Broken Hill Police Station

Access Review - Final

25 August 2020

DRAWING TITLE
Development Application
Ground Floor Plan - RL.+307.040

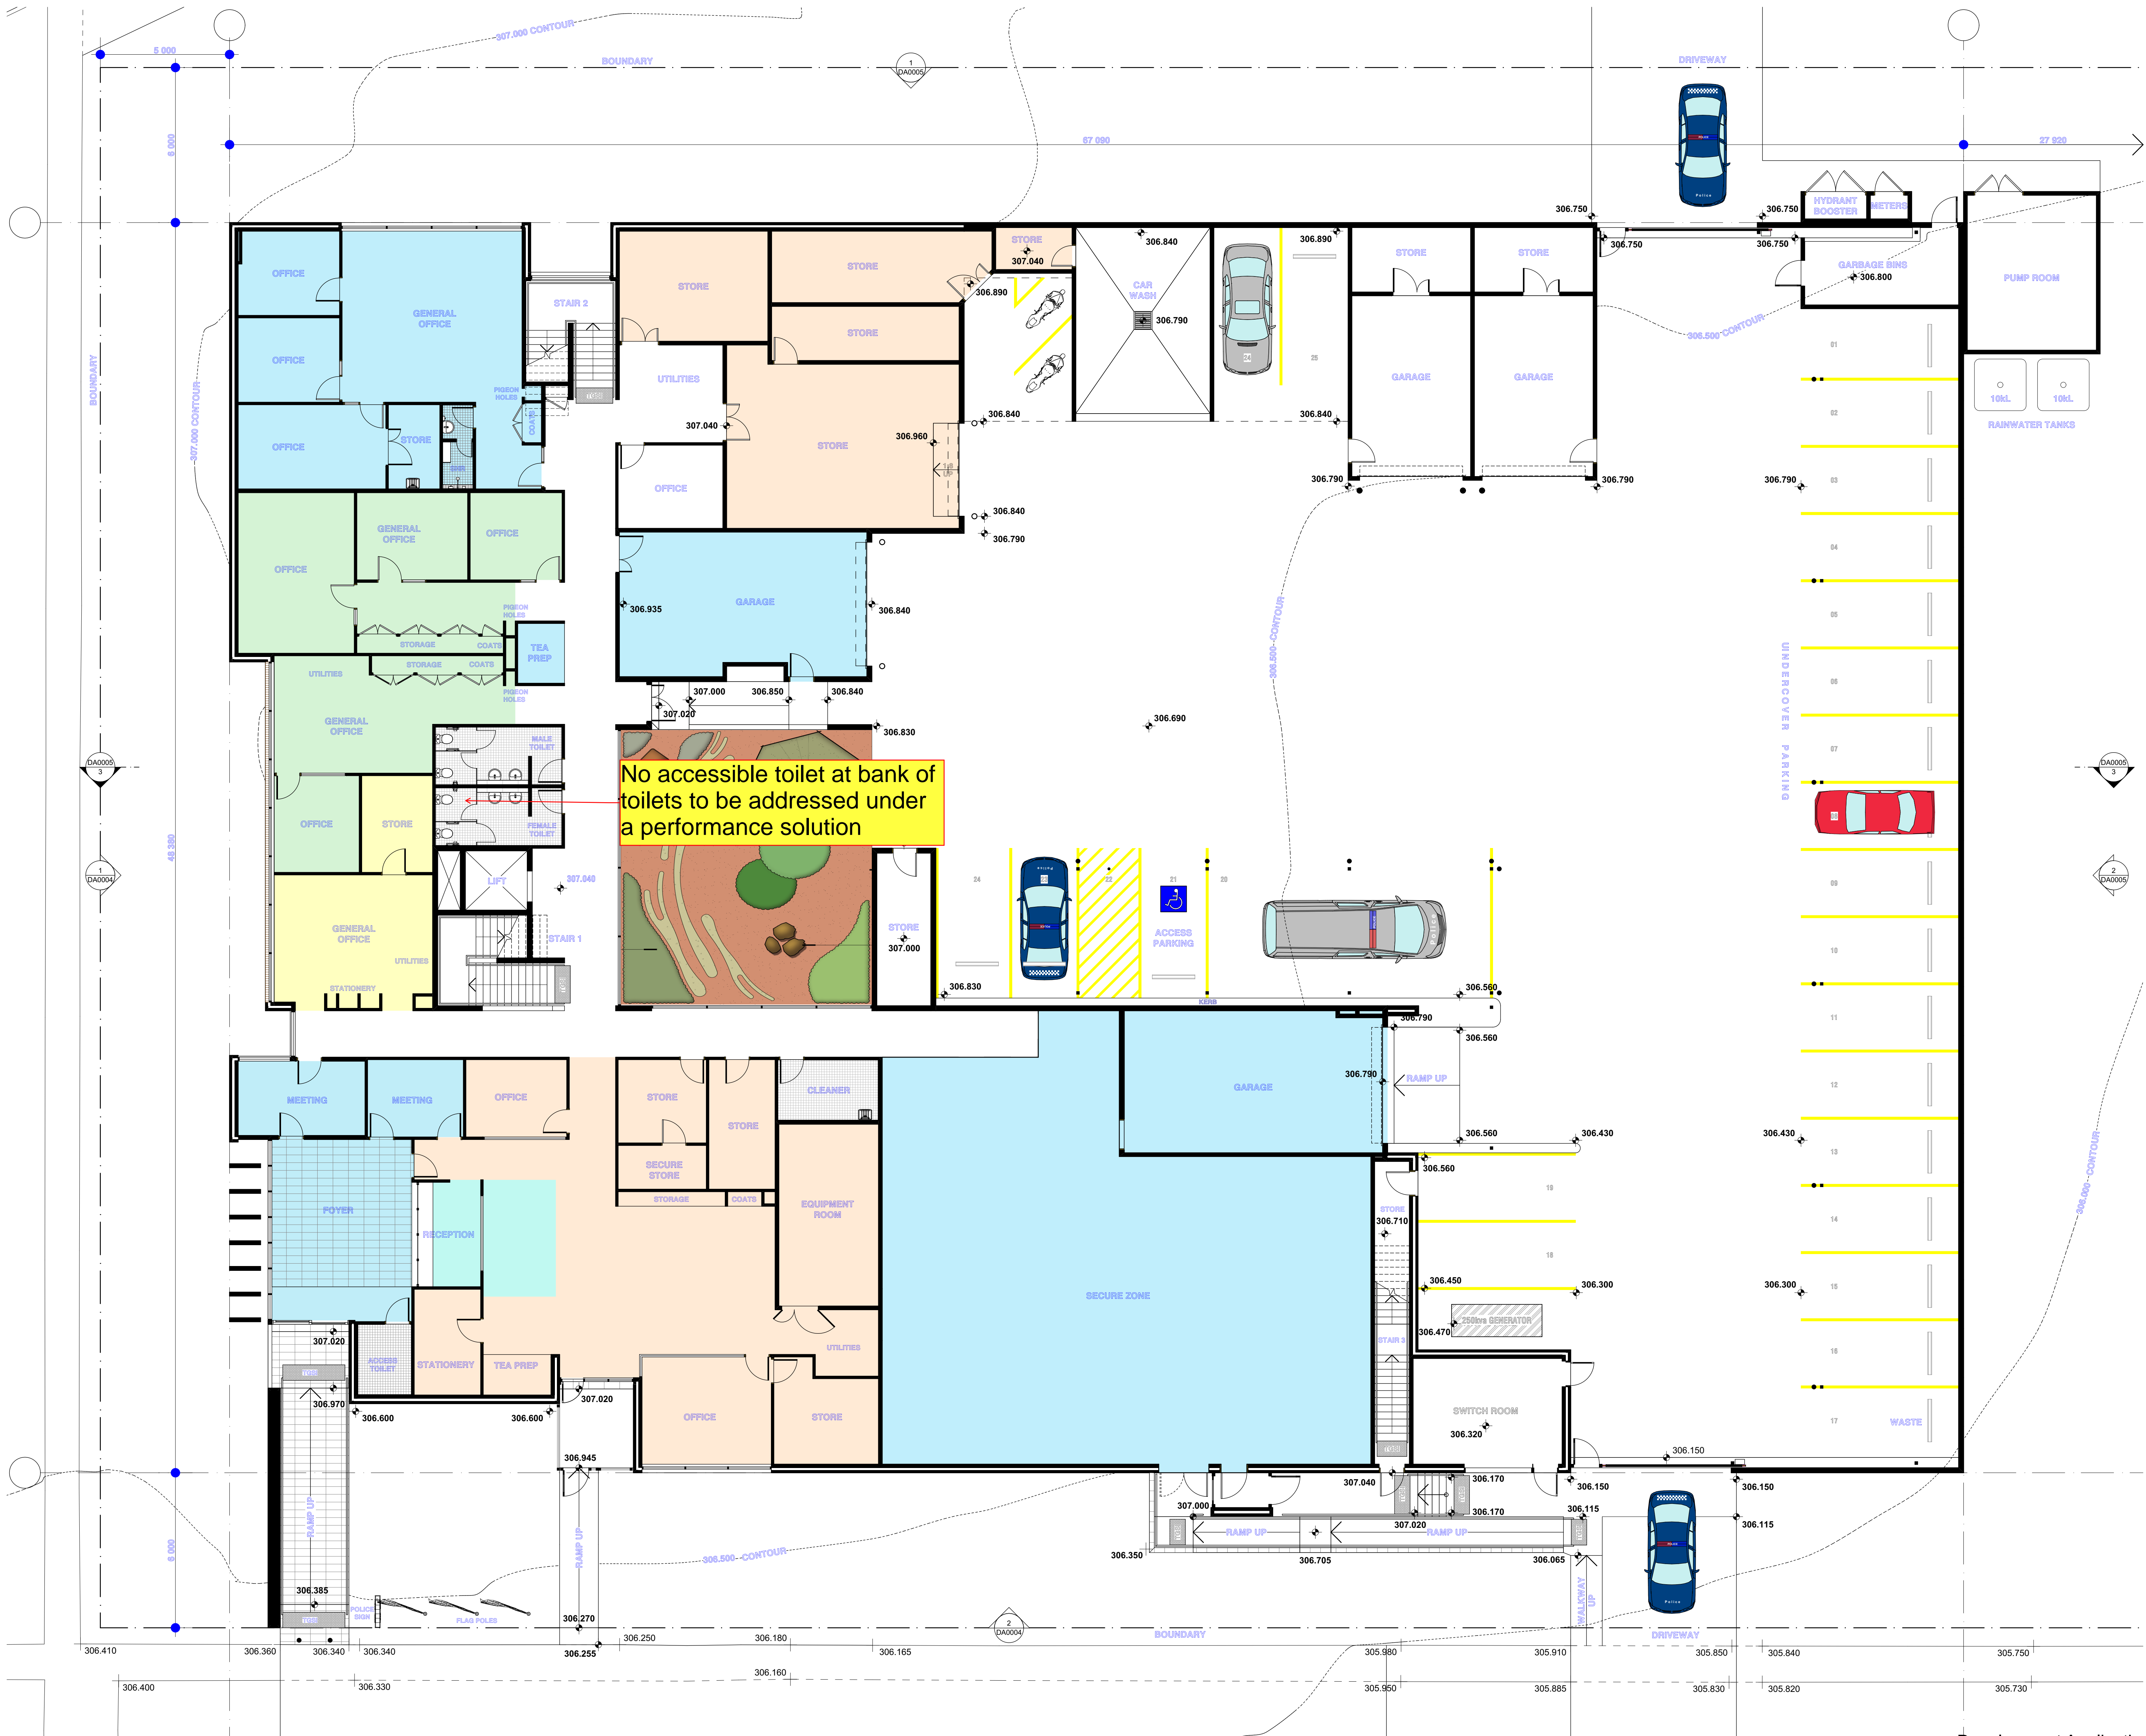
- 1500mm clear opening needed on entry ramp to allow for wheelchair right angle turn
- Increase corridor width to 1.8m on first floor to allow for wheelchair passing bay
- Increase latch side clearances on x4 doors on first floor

- Accessible toilet on ground floor to be extended to 2730mm in length
